Wiltshire Council Planning Consultation Response

URBAN DESIGN

Application No: PL/2026/00135

Proposal: Approval of reserved matters for the demolition of existing structures and construction of 90 homes, with areas of open space, a play area, sustainable drainage infrastructure, internal roads, paths and parking areas, landscaping and associated works, plant and infrastructure and discharge of conditions 7 (boundary with Abberd Farm), 8 (Surface Water), 9 (Surface Water), 14 (Construction Ecological Management Plan), 15 (Landscape Ecological Management Plan), 16 (Lighting), 17 (Wildlife Features) and 18 (Noise Assessment) of outline planning permission PL/2022/07893
Land off Spitfire Road, Calne. SN11 8TE

Block A (no windows)

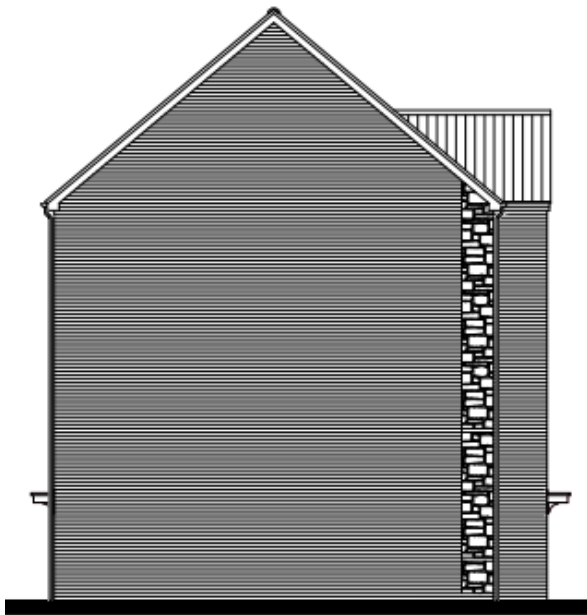
- 7) Street/street corner return elevations and street/open space corner return elevations have largely attractively placed and proportioned windows utilising house types that are consciously designed for this purpose, but there are the following exceptions below in locations. These would represent ‘what red looks like’ BfHL (pp 54-55) rather than the preferred ‘what green looks like’ (pp 52-53), and WDG expectation 4.2.8. *‘Where buildings are on a corner both public elevations should be designed as ‘frontages’ and have windows from habitable rooms in them’*

✓ Reason – includes dining room windows

Plot 18 Totley (no windows), Plot 38 (first floor WC only) ✗ Reason - The matter has not been resolved.

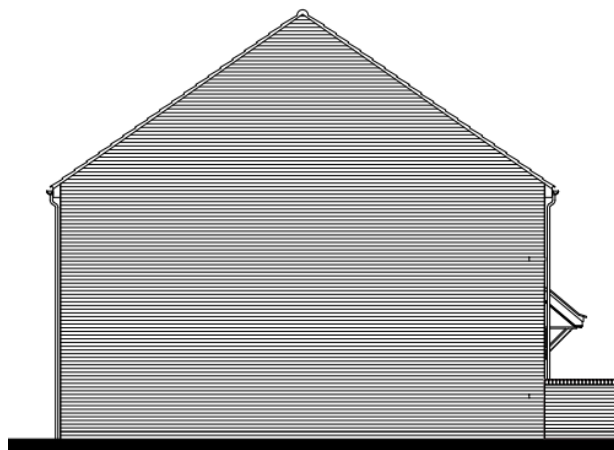
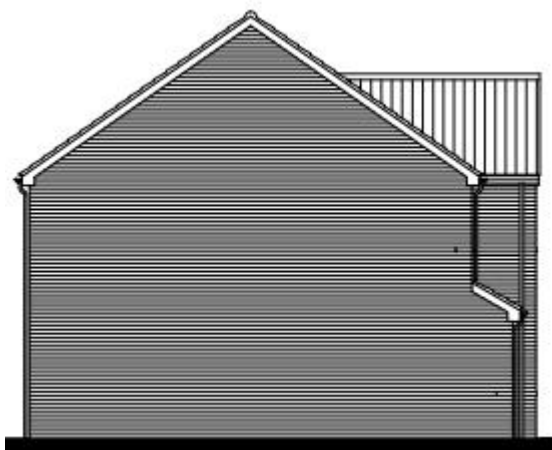
Plot 76 Fulford (wc window only)
 ✓ Reason – Plots 73, 85,86 includes a dining room window

Plot 86 Lytham (no windows)
 ✓ Reason – Lytham type no longer included
